REVIEW COMMENT TABLE

Diavik - WL Amendment - PK to Mine Workings - DDMI Response to WLWB Information Request (W2015L2-0001) (WLWB)

DDMI provided its Response to the WLWB's IR on November 6, 2018.

Figure 1: Time Series for A418 Pit Lake Parameters under “What If” (Turnover) Scenario

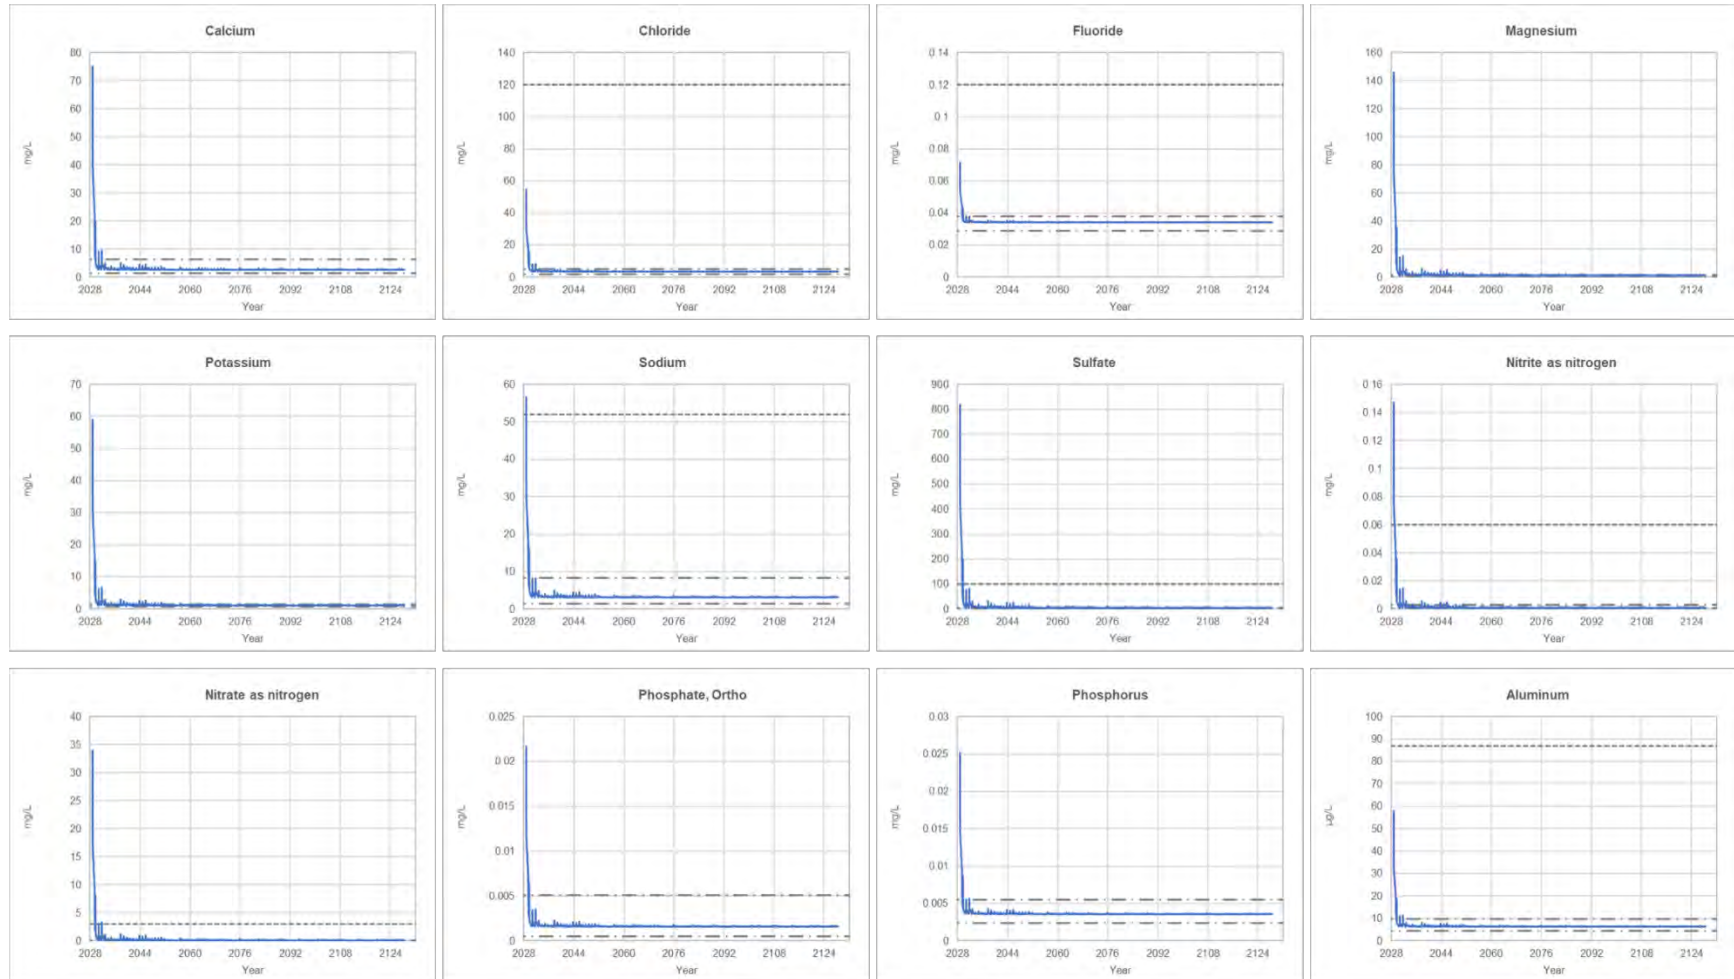
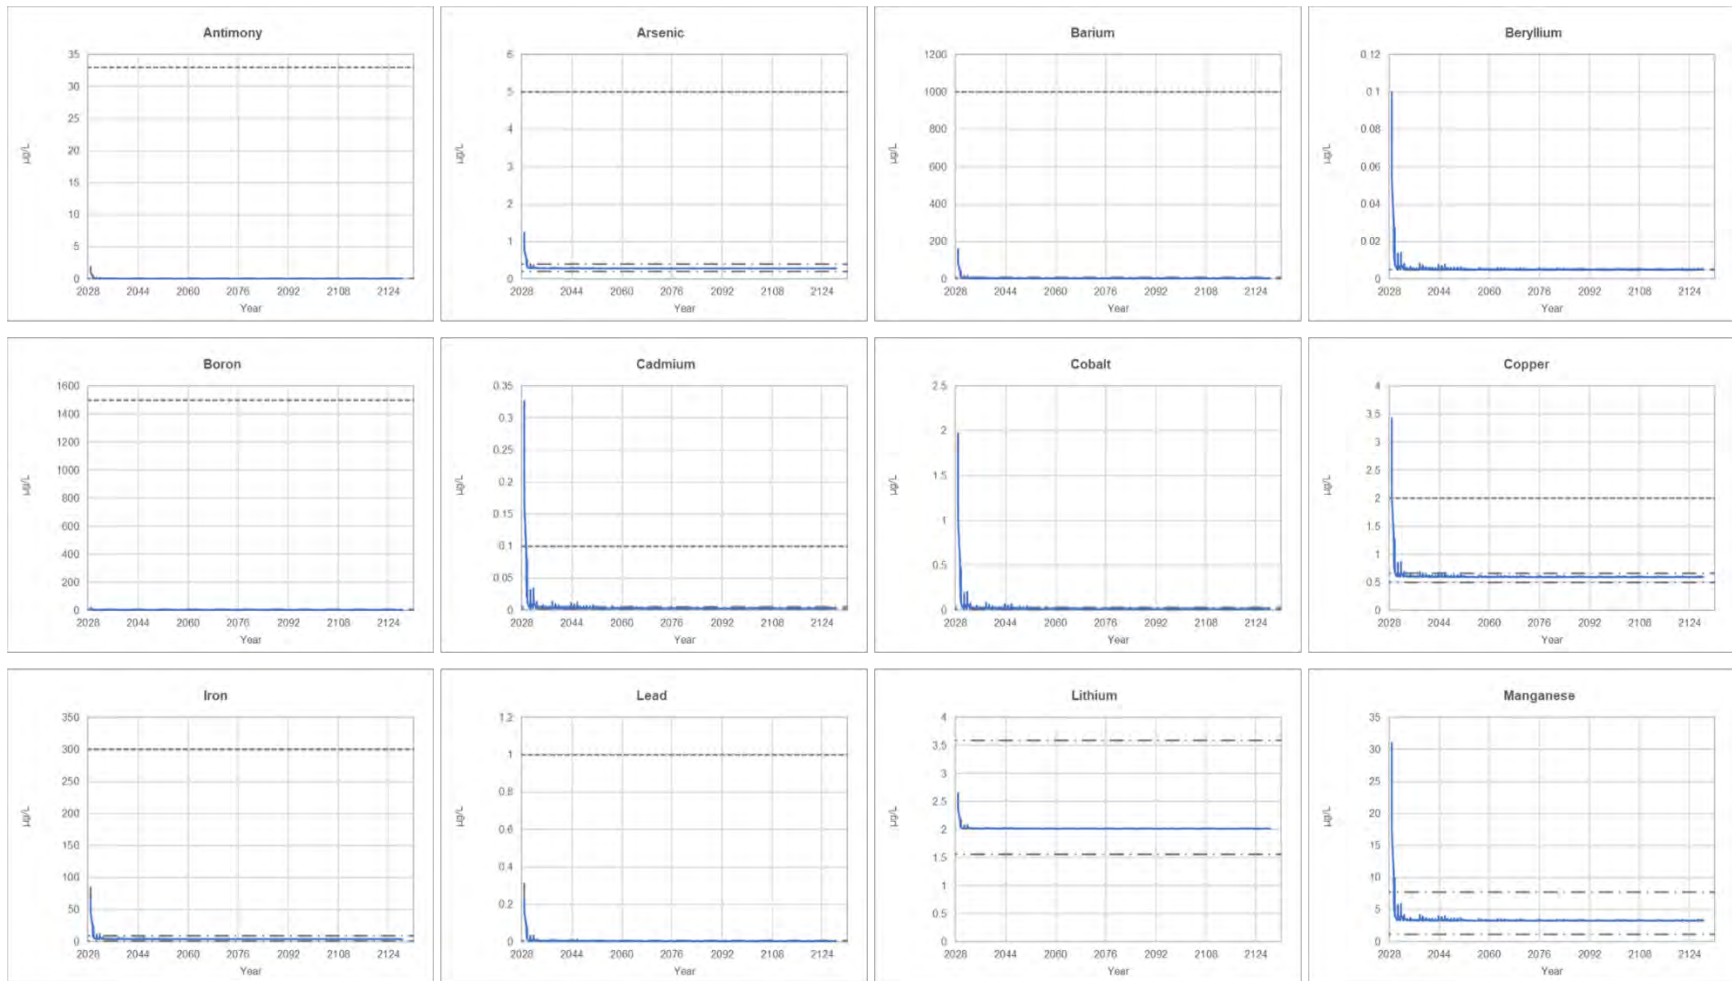
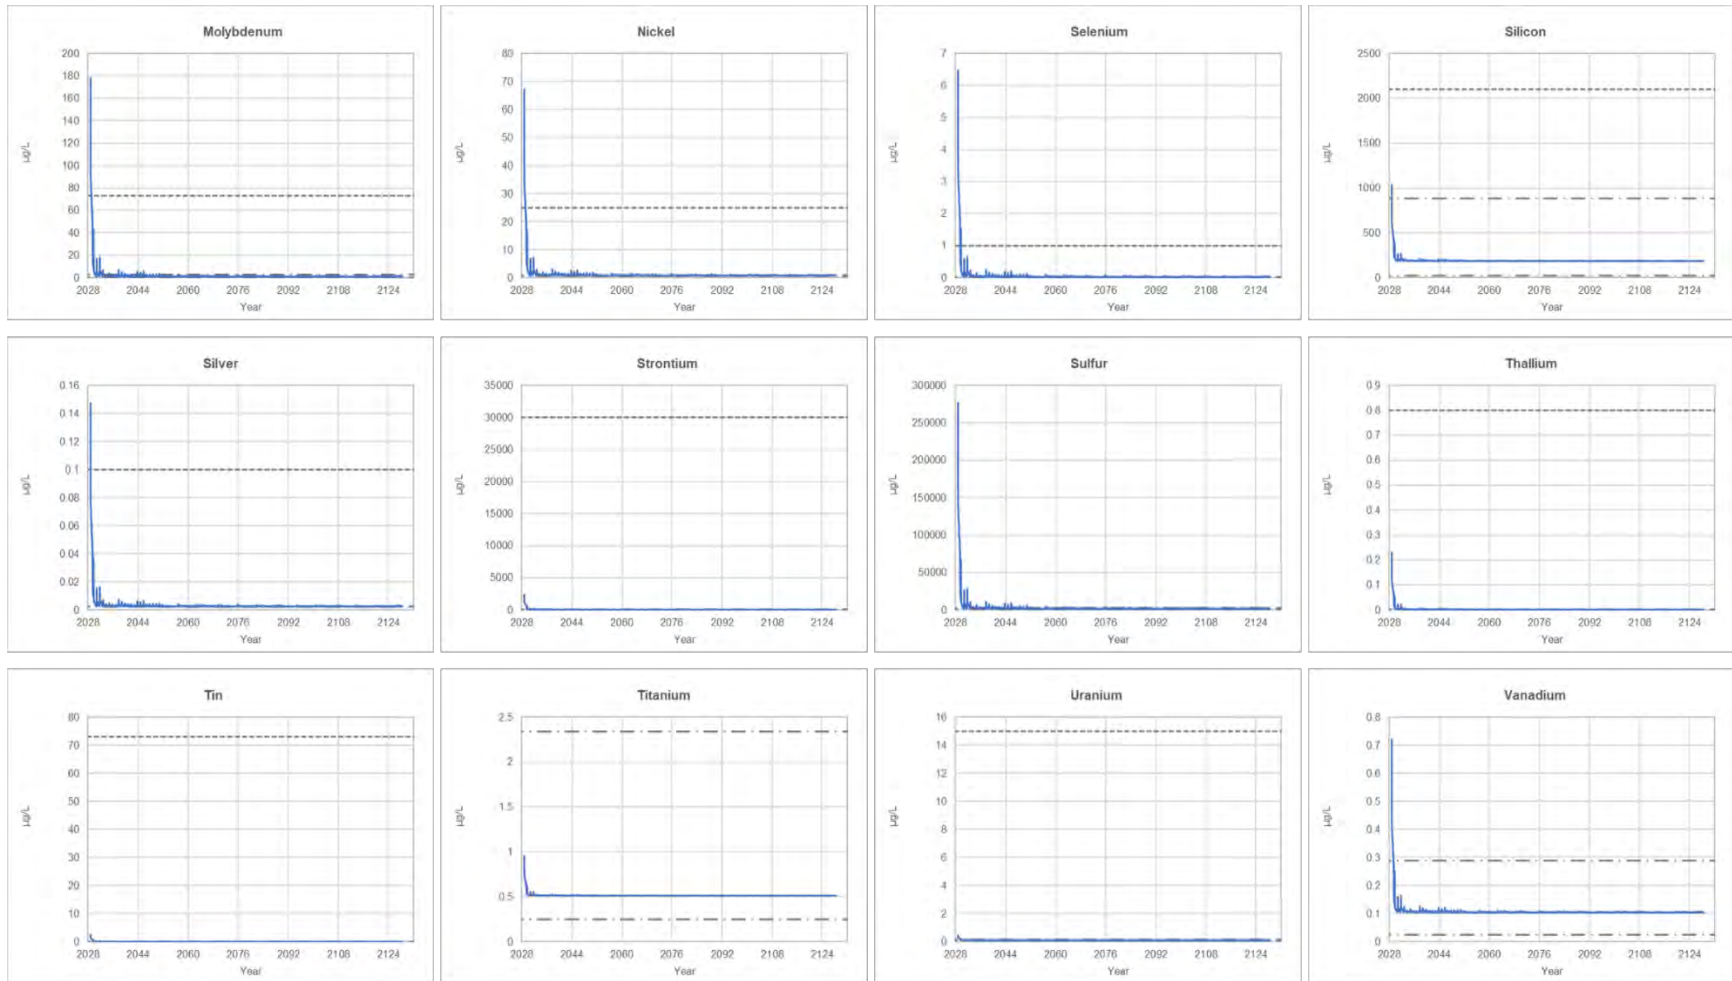
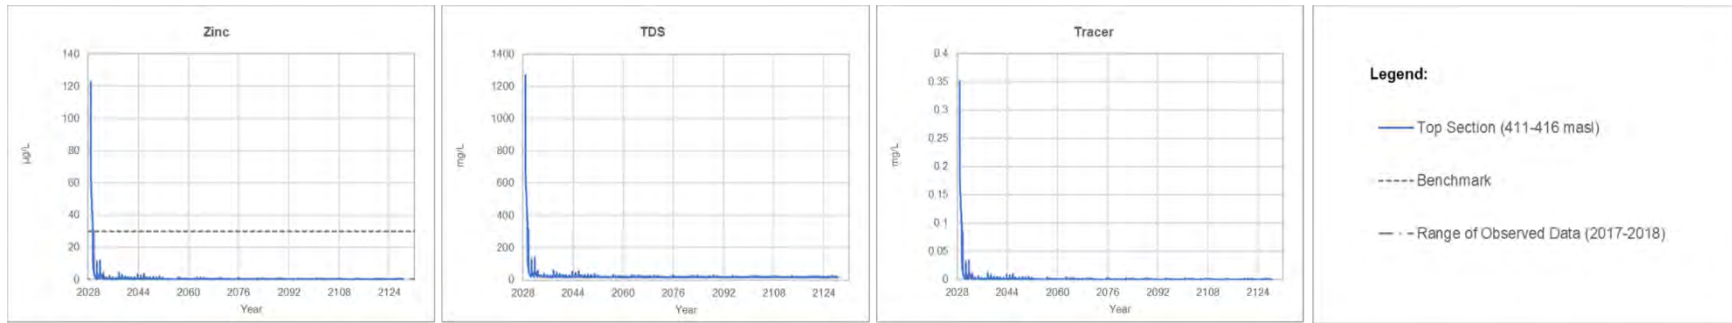
6	Meromixis and long term stability of the stratification.	<p>Comment The quality of the water in the stratified layer is of major concern if this layer was to mix with surface water in Lac de Gras. The layer will contain essentially all of the porewater released from PK consolidation and could also be anoxic (no oxygen). Mixing of this mass of porewater with the surface water could have a material impact on water quality and fish in the pit lake. The mixing of the stratified water with Lac de Gras was modelled and indicated some elevated levels of several contaminants. The report suggests this will be a short-term issue (one to two months) based on Sensitivity Scenario 2 (20 m water cap) however this has not been demonstrated. The 150 m water cap scenario would be expected to take longer to reach equilibrium with Lac de Gras due to the higher volume of water in the cap. The base case suggested mixing is most likely to occur in October just prior to freeze up, which would also be expected to delay mixing. It will therefore be important to model water quality for this period to assess how long elevated conditions exist and whether this will have any impact on fisheries. The Pit Lakes post closure are planned to provide nursery and rearing habitat for fish, in particular Lake Trout and Cisco. These life stages may be more sensitive to degradation of water quality. Could infrequent mixing of the water column result in the mortality of juveniles inhabiting these areas?</p> <p>Recommendation Diavik should rerun the case where the pit destratifies and fully mixes. The modelled destratification should occur in October just prior to freeze up. Define a "short lived" duration for the 150 m water cap scenario ie. how long would it take for conditions to return to levels below the AEMP benchmarks? Assess what effect low DO levels and contaminants of concern have on water quality and fish. Please provide an assessment of the sensitivity of early life stages of fish to the potential infrequent mixing of the water column.</p>	<p>Jan 8: To assist in providing context to this unlikely event duration Golder has provided a further consideration of potential effects and duration of infrequent mixing of the water column in Attachment #8.</p>

The first day of the simulation (i.e., when the turnover occurs) had the highest maximum concentration, after which concentrations decrease in the water column as a result of flow exchange between the pit lake and Lac de Gras. The concentrations over the 100 year simulation period are presented in Figure 1. A discussion of the potential for DO depletion during an unanticipated mixing event and the potential effects of low DO on fish (including early life stages) is presented in the response to EMAB-30.

In the A418 pit lake, under the “what if” scenario (i.e., if turnover occurred), surface water will exceed AEMP chronic effects benchmarks for sodium (as a proxy for total dissolved solids), sulfate, nitrite as nitrogen, nitrate as nitrogen, cadmium, copper, molybdenum, nickel, selenium, silver and zinc. As the time series presented below show (Figure 1), it would take an estimated one to two years for conditions within the pit to fall below AEMP benchmarks for all parameters following turnover.

Figure 1: Contour Plots of Predicted Tracer Concentrations in the A418 Pit Lake

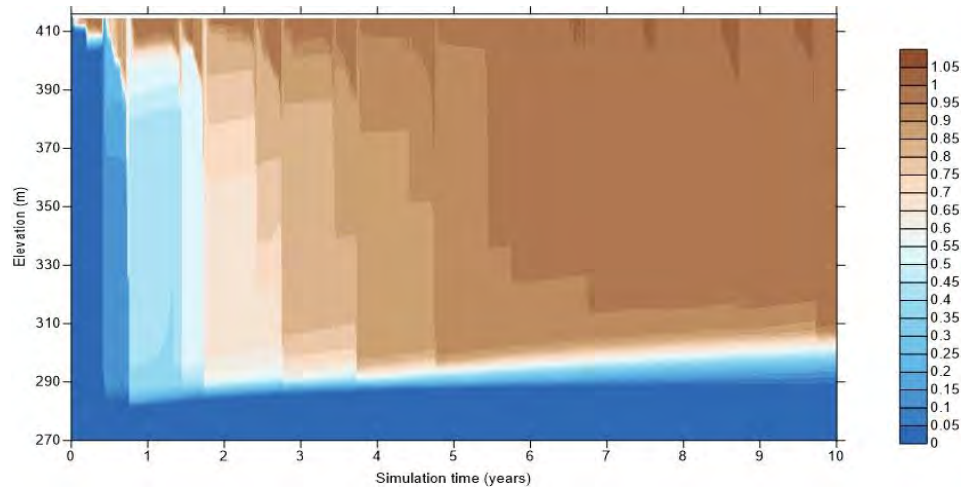
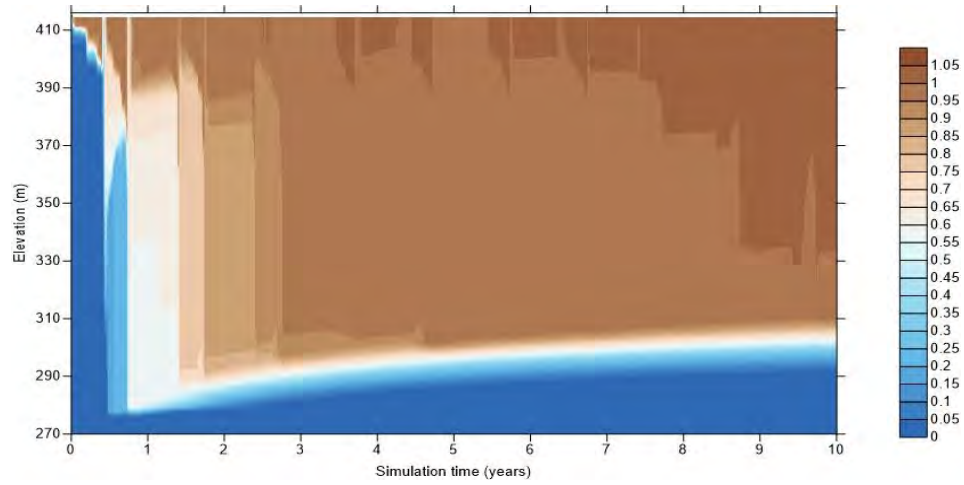
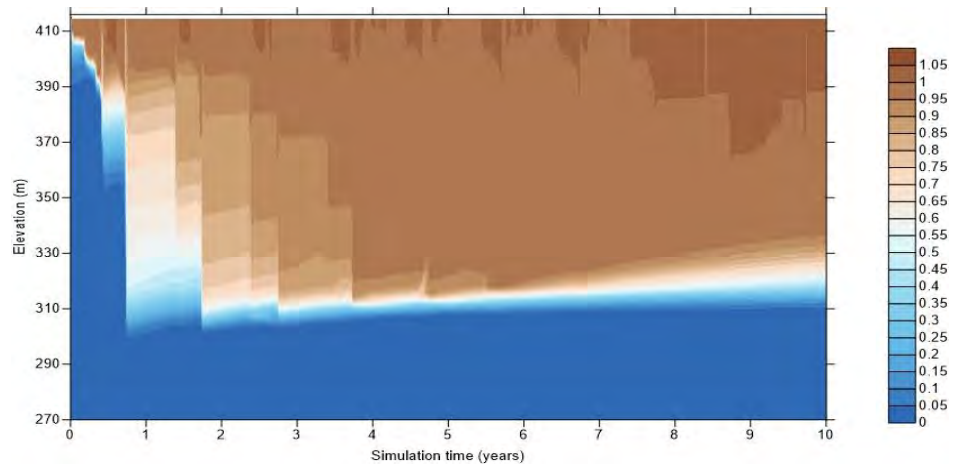
9	<p>Water circulation between the pit lake and Lac du Gras</p>	<p>Comment The Closure and Reclamation Plan V. 4 (App X2, page 8) notes that with regard to water circulation within the diked area, several features should be incorporated to reduce circulation. The shallow nature of the breaches, shallow nature of the pit shelf, and the creation of shoals on the pit shelf will reduce circulation</p>	<p>Jan 8: The model applied in Golder (2018) is a 2-dimensional hydrodynamic model with limited connection to Lac de Gras. It cannot be used to examine fine details regarding currents within a complex habitat. Rather, it is focused on the bulk movement of water through breached dykes. The two sets of predictions are</p>

DDMI Response to EMAB-9

Figure 4: Contour Plots of Predicted Total Dissolved Solids and Tracer Concentrations in the A418 Pit Lake: Development Case Scenario with AZMAX 0.001 m²/s (on the left); Development Case Scenario with AZMAX 1 m²/s (on the right)

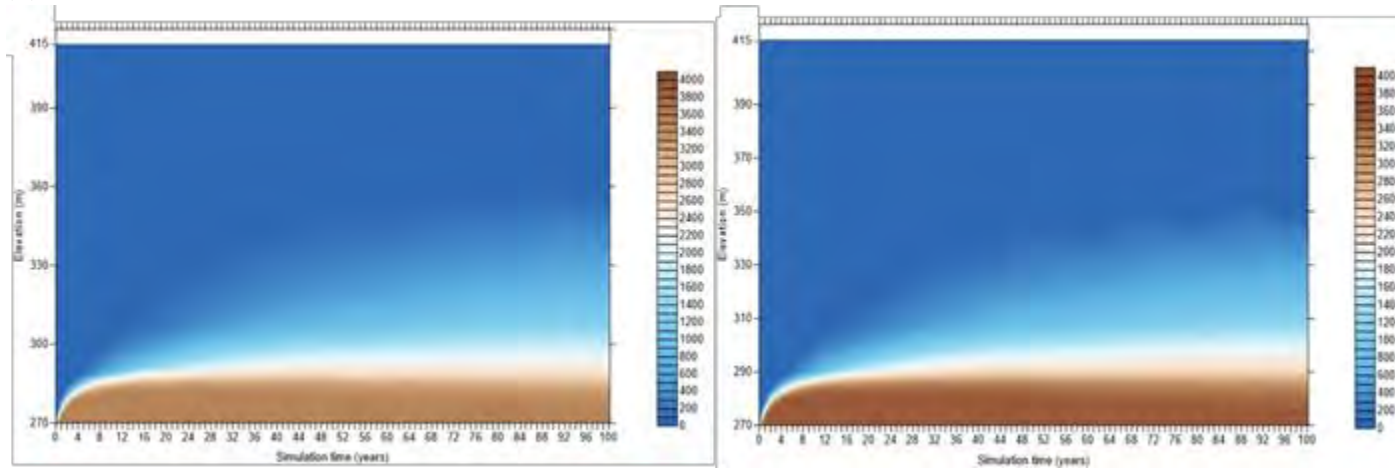
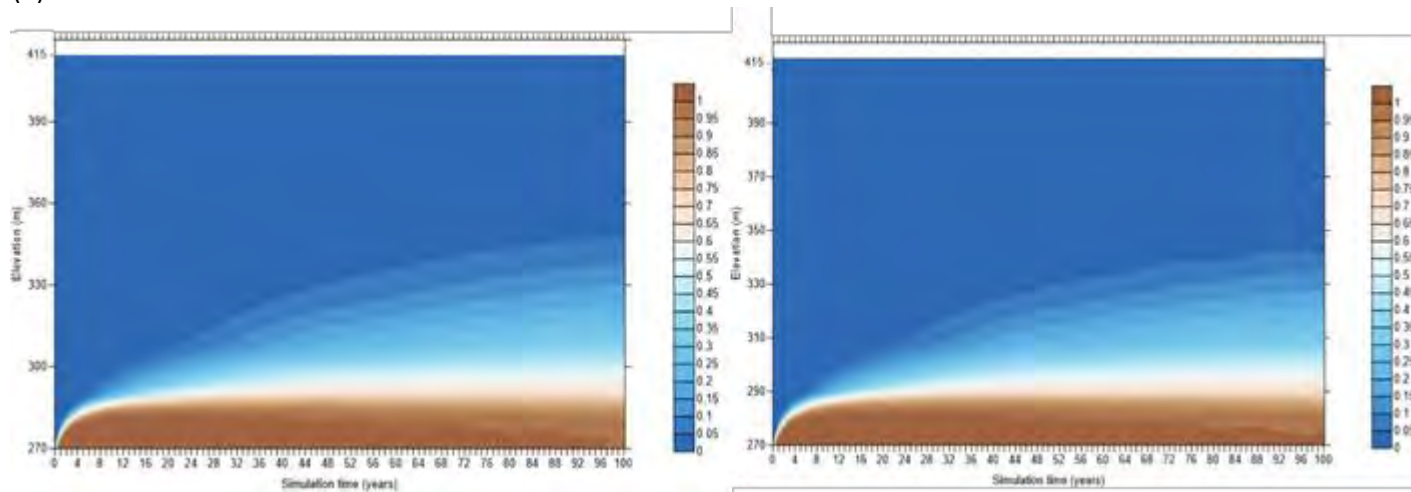
8	Hydrodynamic model rates and coefficients	<p>Comment As noted by Zajdlik and ARKTIS regarding the hydrodynamic model, the maximum vertical eddy viscosity is set to 0.001 m²/s, which are three orders of magnitude lower than the default (1 m²/s). Comments in C-35 Appendix (Coles and Wells 2011) seem to indicate that choosing a maximum vertical eddy viscosity other than 1 m²/s is for backwards compatibility only. This point has also been raised by GNWT in the past in the context of the Jay Pit development and a verbal answer from Dominion Diamond Mines ULC and Golder during a technical modeling workshop in Mississauga, Ontario on July 6, 2015 was that this was part of the calibration exercise. Cole and Wells (2011) emphasize the requirement for adequate and appropriate calibration. It is understood that calibration cannot occur for a pit lake that has not yet been constructed but the lack of discussion</p>	<p>Jan 8: 1) The value referred to in the model is the "maximum value of the vertical eddy viscosity" or AZMAX. Setting this value to a higher number allows for more turbulent systems, such as the rivers and estuaries that are referred to in the CE-QUAL-W2 User Manual (Cole and Wells 2008). The values provided in that document are 0.00001 m²/s for a stratified reservoir to 1 to 5 m²/s for more turbulent systems such as rivers or estuaries. This maximum value improves model efficiency and does not affect results for low-turbulence systems such as a deep reservoirs because the maximum value is higher than the applied value. As noted by Cole and Wells (2008), "Setting [AZSLC] to EXP and [AZMAX] greater than 1.0E-2 will result in very low model time steps." This, in turn, can lead to long run times and numerical dispersion. For these reasons, the value of 0.001 m²/s was deemed to balance</p>

<p>regarding how calibration choices could affect model outcomes is notable. DDMI (Golder 2018 Section 3.0) does state that rates and coefficients are a source of model uncertainty.</p> <p>Recommendation 1) ENR recommends that DDMI discuss why the very low vertical eddy viscosity value was selected. 2) ENR recommends that given the importance Coles and Wells (2011) ascribe to calibration, DDMI should perform a sensitivity analysis of the rates and coefficients used in those variables used to calibrate the model under at least one modeling scenario. 3) ENR recommends that DDMI should provide conceptual drawings for each model with an overall diagram showing linkages between models. This should be accompanied by all default rates and coefficients with a rationalization for the selected values. 4) ENR recommends that DDMI provide a sensitivity analysis to determine which parameters and / or assumptions most affect modelling conclusions.</p>	<p>computational efficiency can be improved by conservatism. The value applied in the model (0.001 m²/s) is on the low to mid end of the range, which is likely conservative because the pit lake would behave more similar to a reservoir. To evaluate whether the value selected for AZMAX affected the results of the model, a value of 1 m²/s was used in the sensitivity analysis (response to EMAB-14). For comparison, the contour plots of TDS and tracer are shown in Figure 4. This figure shows the development case from figures 5 and 6 of the report, along with a sensitivity scenario using AZMAX=1 m²/s. This simulation shows that the vertical mixing was not affected by the choice of a higher value. There are small differences in results, possibly due to changes in time step, or infrequent events. The vertical eddy viscosity does not become as high as the selected maximum value in this analysis, or does so rarely, and does not affect the overall behaviour of the system or conclusions drawn from the simulations completed using the lower value. As mentioned elsewhere, the modelling completed to date is preliminary and provides a suitable level of understanding to proceed to more detailed studies. 2) Please see the response to part 1. 3) There are no linked models for this preliminary modelling. Each pit lake has its own hydrodynamic model, and pore water was entered into the hydrodynamic model as a time series. Model linkages may be included in more detailed evaluations in the future. 4) A sensitivity analysis has been undertaken, as described in the response to EMAB-14.</p>
